March 28 2024 BOCC
FOREST HEIGHTS ESTATES MS206
Adjacent Landowner (since 1969) Parcel 108
Judith von Ahlefeldt 8255 Forest Heights Circle

PROPOSED CONSTRUCTION DRAWINGS - PRESENT DESIGN

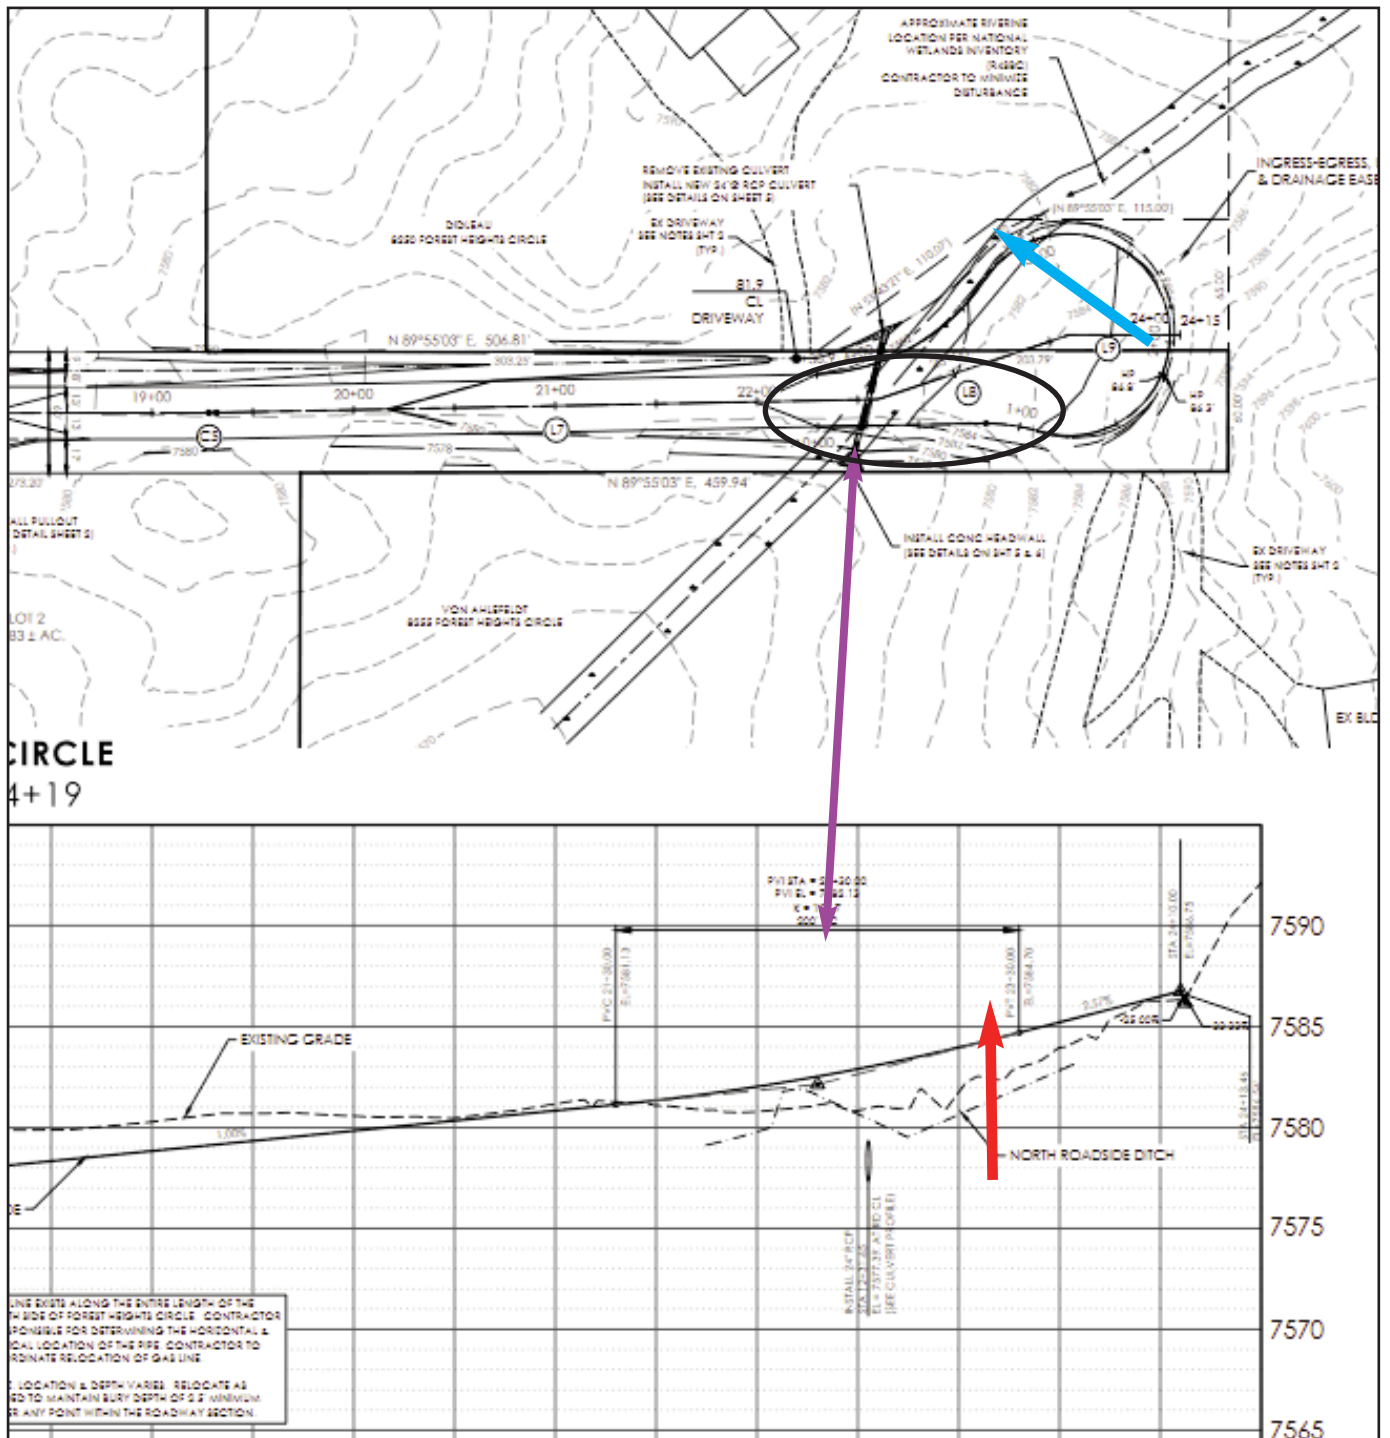
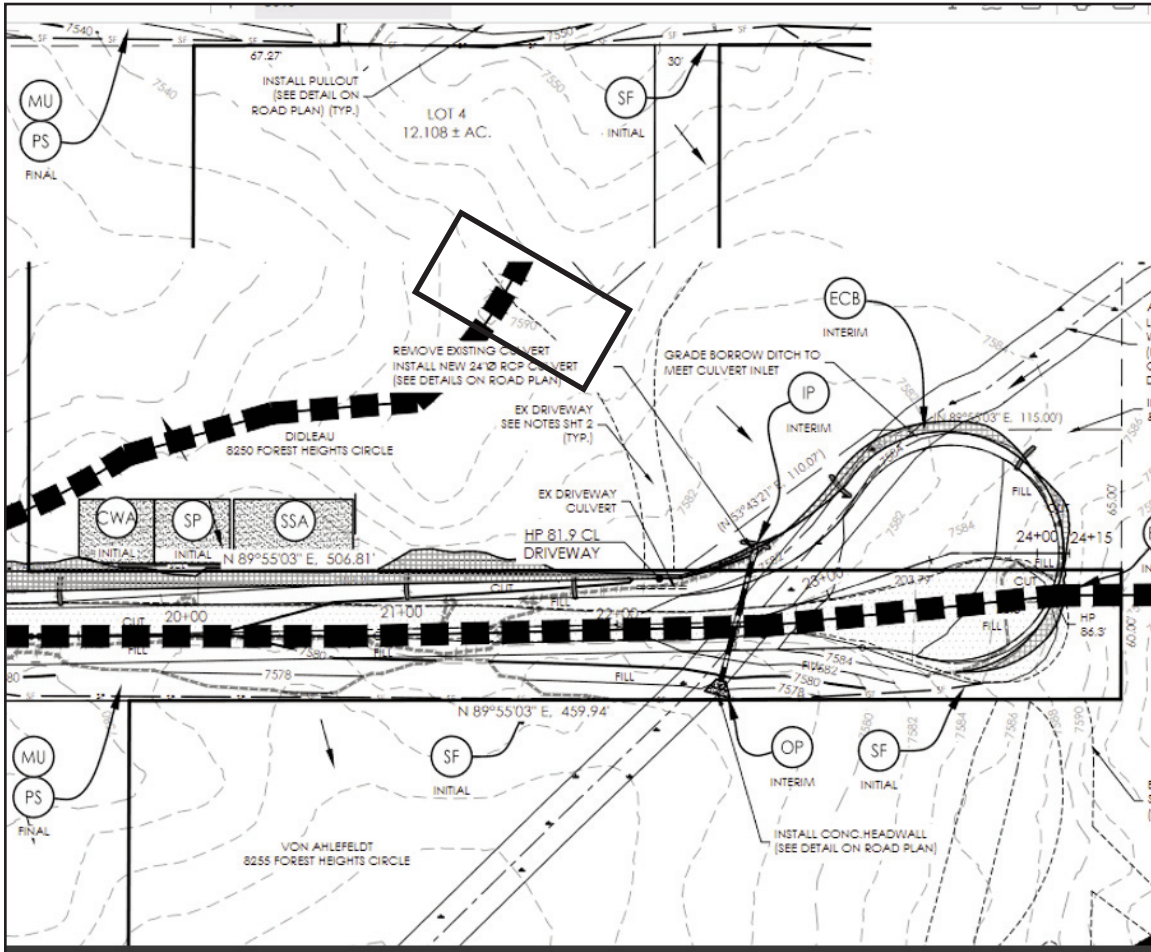
South boundary - SE corner and meadow:

- along Forest Heights Circle, and across from my parcel,
- the egregious, oversized urban cul-de sac which prescribes filling Phyllis' wetland,
- installing a 56-foot 24-inch culvert (presently fuctional 18 inch culvert is 18")
- drainage across the 100' diameter cul de sac forces outflow down a fill slope to the nearby culvert inlet (sedimentation likely),
- culvert outlet has a headwall, riprap and is against my fenceline at the meadow

South Boundary - SW corner - remove hill and flattened CWA - Concrete washout, SP - Stockpile Protection, SSA - Stabilized Staging Area Over - over half of Phyllis' property line will be disturbed and regrad-

- Move the cul de sac west and build it in on the flat upland area used for construction support. Build the cul de sac last.
- Use same design as for the east road position - surface drainage for cul de sac is to NW also and into the ditches.
- Culvert 2 is already upsized to 24 inches, and the north side Forest Heights' borrow ditch has erosion and water velocity mitigation already planned.
- This will save a lot of construction cost - shorter road, no massive fill needed for the cul de sac, no need for 56 foot 24" culvert, or riprap and headwall.
